LANDSCAPE CONSULTATION COMMENTS - 186/20/CON

Application: 202604
Address: Land at Brook Meadows, Tiptree, Colchester
Description: Outline application for the erection of up to 221 dwellings and associated infrastructure and works.
Response Date: 21/04/21
Site visited: 01/12/20 & 04/02/21

(Map data ©2021 Google) (site

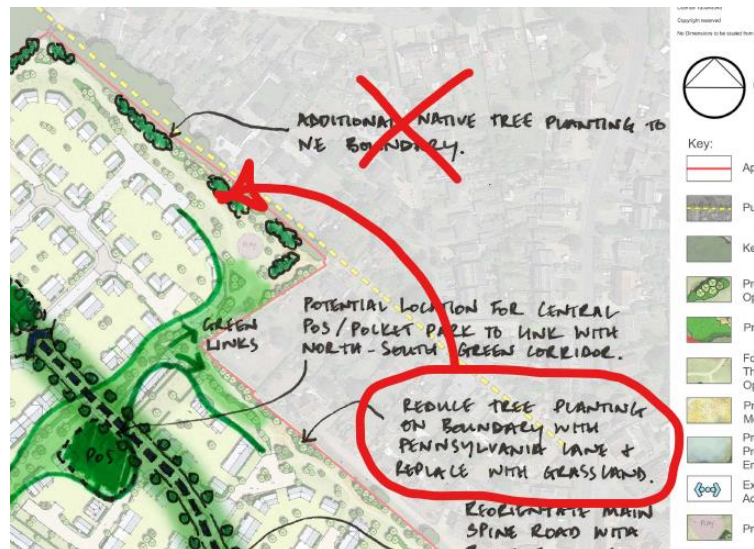
- The site description given within the Baseline Assessment under part 2 of the LVIA would appear for the most part acceptable. However, the description in 2.1 and 2.3 of the site and the field to the north-west of it as both being large fields needs to be reconsidered. This as these fields form part of the characteristic mosaic of small to medium sized fields to CBLCA F2 as noted in 1.4 above, i.e. fields within CBLCA F2 are specifically defined as either small or medium sized, unless noticeably much larger than other fields within the Area. In this case when assessing these fields against those around them, it can be seen here

outlined red, NW field in orange and CBLCA F2 in blue) that they are both not noticeably larger, nor particularly smaller than other fields in CBLCA F2, ergo they are both medium size fields characteristic of CBLCA F2, which is characterised by a mosaic of small to medium sized fields. Any revised LVIA should therefore revise all description of the site (and the field to the NW) as being medium size, and following on from that acknowledge within it's assessment that the proposed development would involve the loss of a characteristic part of CBLCA F2 through the loss of this medium sized field, revising the findings of the LVIA accordingly.
